NUMBER
ABATMNT12

Addendum Number: 01

1. To provide additional bid scenario pages previously omitted in error.
2. To provide addendum acknowledgment.

ATTACHMENT A

BID SCENARIO NUMBER 1

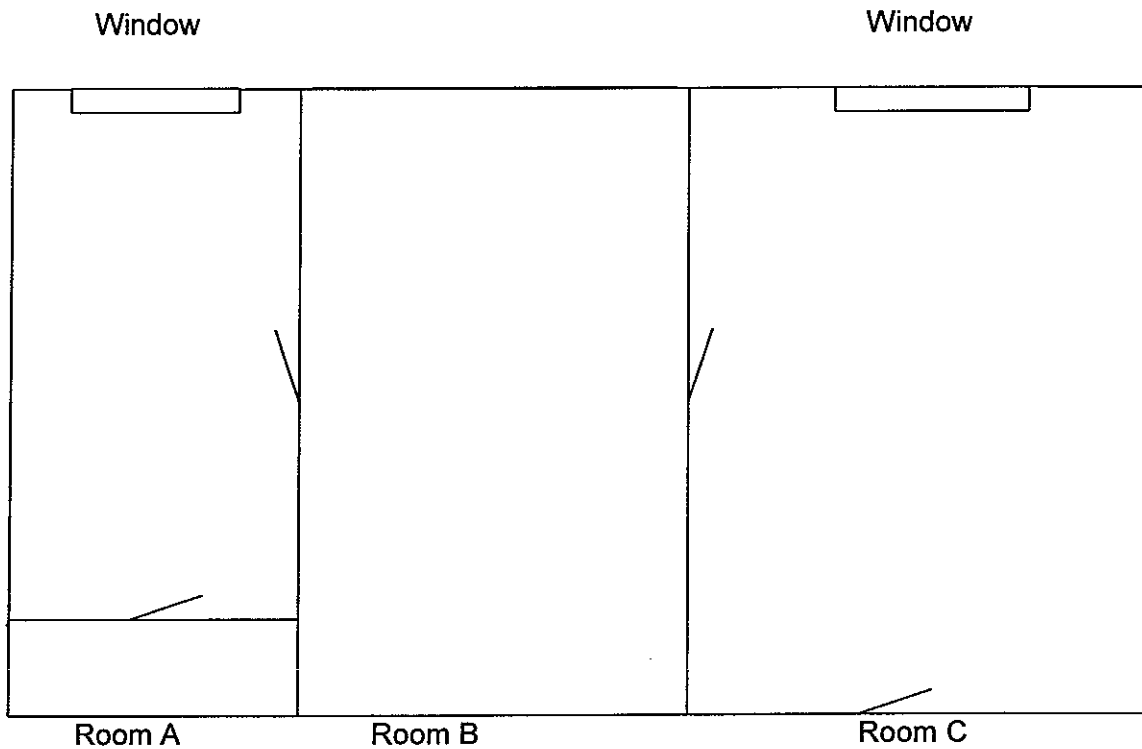
Remove carpet and abate tile and mastic in three office spaces.

Room A is 10 feet by 15 feet.

Room B is 20 feet by 12 feet.

Room C is 21 feet by 14 feet.

The area is on the third floor of a six story building. The area around the offices is occupied during normal working hours.

BID SCENARIO NUMBER 2

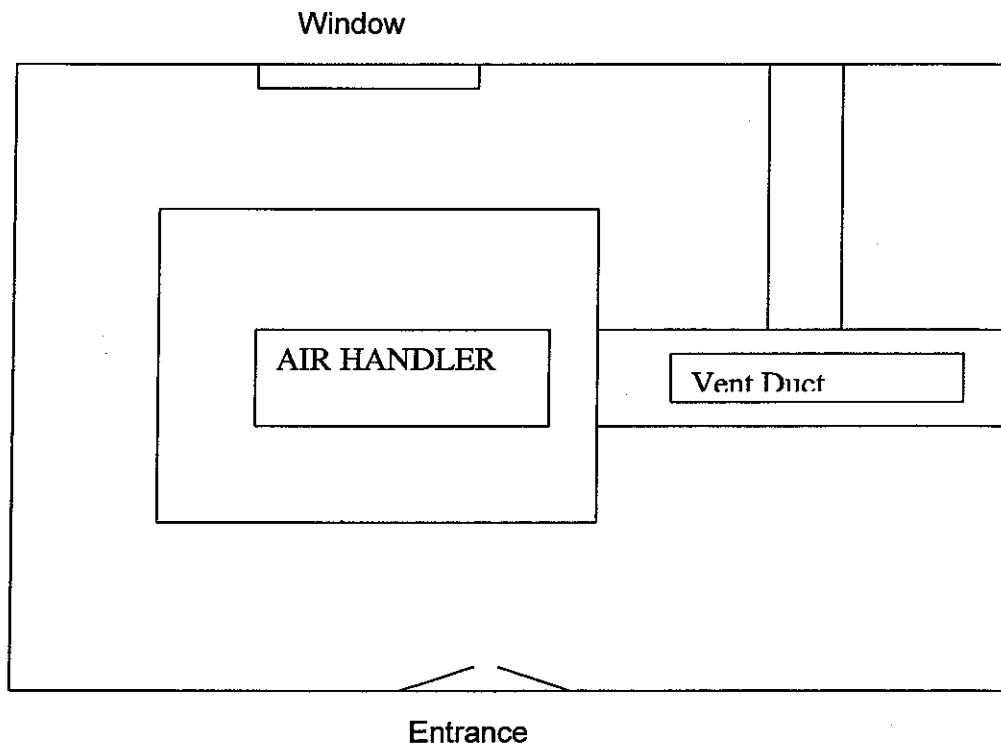
We are requesting bids for the abatement, disposal and re-insulation of Mechanical Room #12 in building 62. The abatement project consists of:

- 980 square feet of $\frac{3}{4}$ inch sheet insulation on the air handler
- 420 square feet of 1 inch sheet insulation on the vent ducting

Chill water piping

- 89 linear feet of 2" piping
- 120 linear feet of 1" piping
- 115 linear feet of 4" piping

Steam piping:

- 32 linear feet of 12" piping 1" thick TSI
- 295 linear feet of 24" piping 2" thick TSI
- 1" tee connections - 15
- 1" valves - 6
- 1" elbows - 10
- 2" elbows - 4
- 2" valves - 2
- 4" elbows - 4
- 4" tees - 2
- 12" elbows - 2
- 24" elbows - 2

All piping and air handler areas are fully accessible. The piping runs from the air handler to the ceiling which is 16 feet high.

BLDG 62 12th Floor

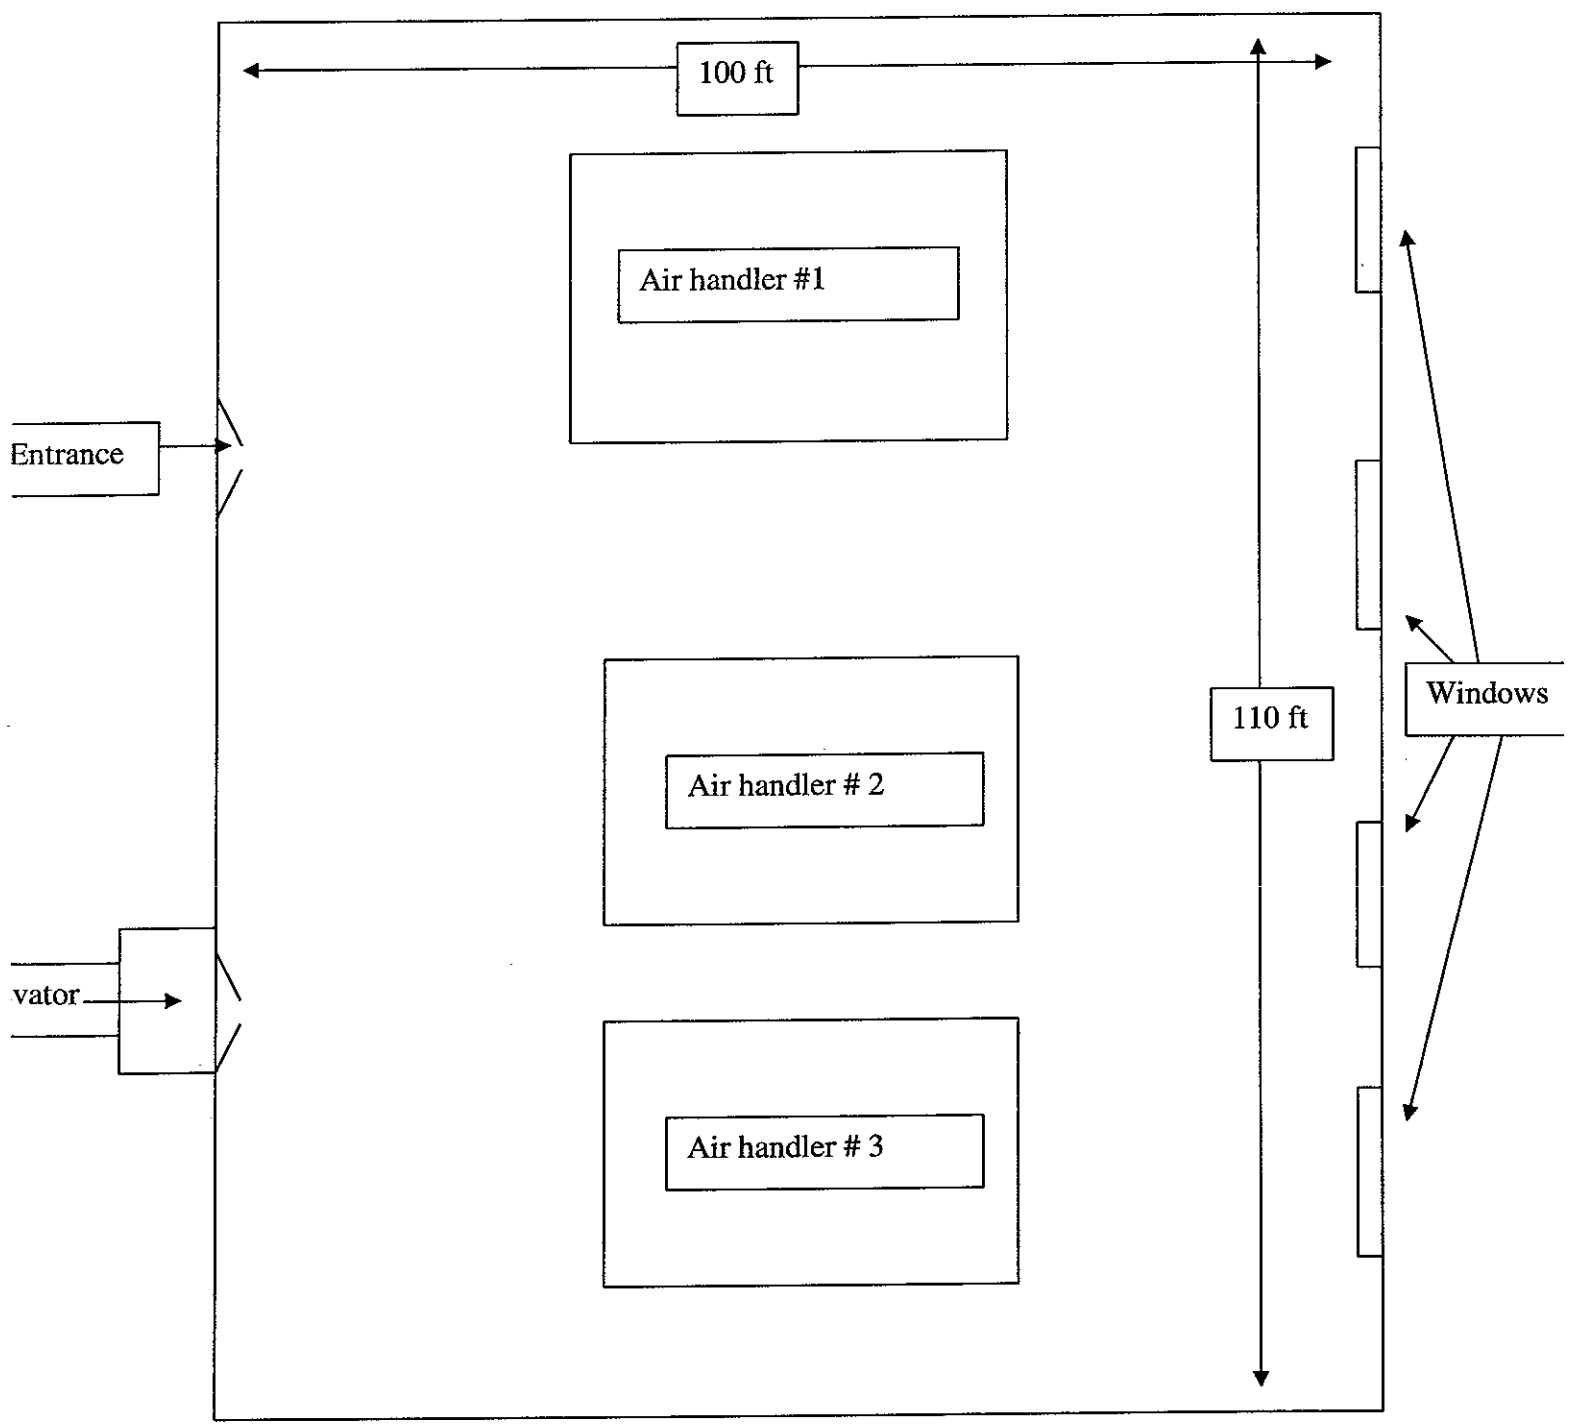
We are requesting bids for the abatement, disposal and re-insulation of Building 62 12th floor Mechanical Room. The abatement project consists of:

11,000 square feet of spray-on insulation
985 square feet of sheet insulation on air handler # 1
765 square feet of sheet insulation on air handler # 2
685 square feet of sheet insulation on air handler # 3

Chill water piping:

175 linear feet of 1" piping
1" tee – 8
1" valves – 16
1" elbows – 24
85 linear feet of 6" piping
6" valves – 6
6" tees – 4
6" elbows – 8
155 linear feet of 2" piping
2" tees – 9
2" elbows – 16
2" valves – 6

Steam Piping:

80 linear feet of 12" piping
12" elbows – 4
12" valves – 2
140 linear feet of 8" piping
8" elbows – 12
8" tees – 6
8" valves – 4

The ceiling is 20 feet high. Steam piping is suspended from the ceiling and is easily accessible. Chill water piping is connected to the air handler unit and run up to the ceiling and is accessible. The area can be secured during the abatement project but must be done at night when tenants are not at work. The air handler units will be shut down. See general layout on the following page.
